Appendix K – Agency Consultation

**Region of Waterloo – University Avenue EA
Stakeholder Consultation Summary Table**

**Re: University Avenue Improvements Class Environmental Assessment
University Avenue (Weber Street to Albert Street), Waterloo**

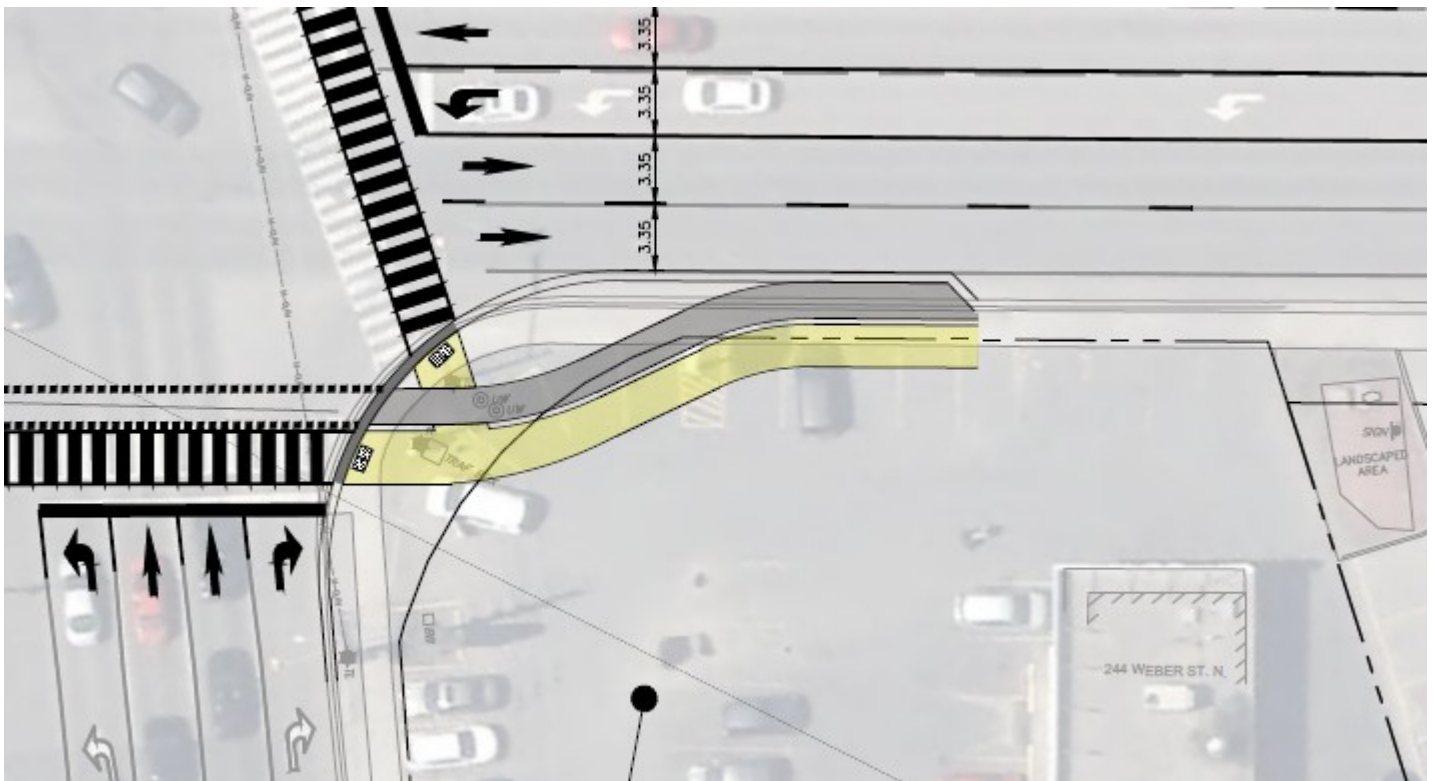
Looking for some clarity on the construction on the Dq/Fresco's corner. From the drawings will the property will be affected or just on the Petro Canada side & if so to what extent. We have a Video street sign very close to the sidewalk within a meter & already a lack of parking that am concerned about.

The recommended concept alternative does identify impacts on the DQ/Fresco corner:

With the conclusion with PCC#2 we will now proceed with detailed engineering design. Our aim here will be to minimize encroachment and impact onto this property. When we have done so, we will want to meet with the owner of this parcel to discuss the details.

For example, we will see how much we can swing the new cycle track and sidewalk coming from the intersection to tie into the existing facilities on University Avenue east of the Weber Street intersection. If we can do this, it will pull back the cycle track to on road cycle lane before your video signboard.
